Technical Bulletin No. TB22.1FL
 July 20, 2022

Potential for Erroneous Low Battery Warnings on the SWIFT Pull Station Products W-BG12LX and W-BG12LXSP (the “Products”)

SWIFT Pull Station Product Labels:

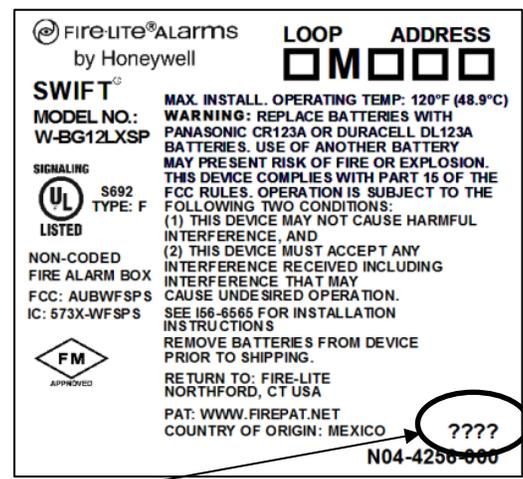
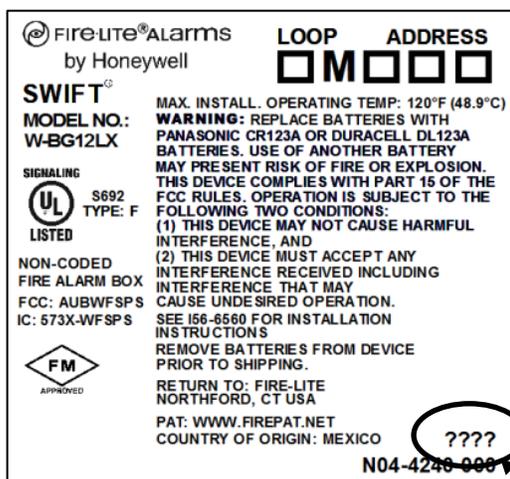
- Potential erroneous low battery warnings may be shown on the SWIFT pull station models W-BG12LX and W-BG12LXSP.
- Potentially impacted products were manufactured with date codes 8xxx, 9xxx, 0xxx, 1xxx, 201x, 202x, 203x [‘x’ indicates any number]. The date code location is shown below.
- SWIFT pull stations not exhibiting a low battery warning do not need to be replaced.

Issue: Although a low battery notification can be generated for legitimate reasons, the models and date codes listed above have the potential to generate a premature and erroneous low battery notification within a few months of installation. This notification is not a safety issue, but low battery warnings should be addressed promptly to avoid potential problems with system operations which may arise.

Action needed: SWIFT pull stations that have been operating without issue do not need to be replaced. The warranty return policy for the Products listed above will be honored and those Products and date codes listed above that are exhibiting premature low battery notices should be returned through normal channels.
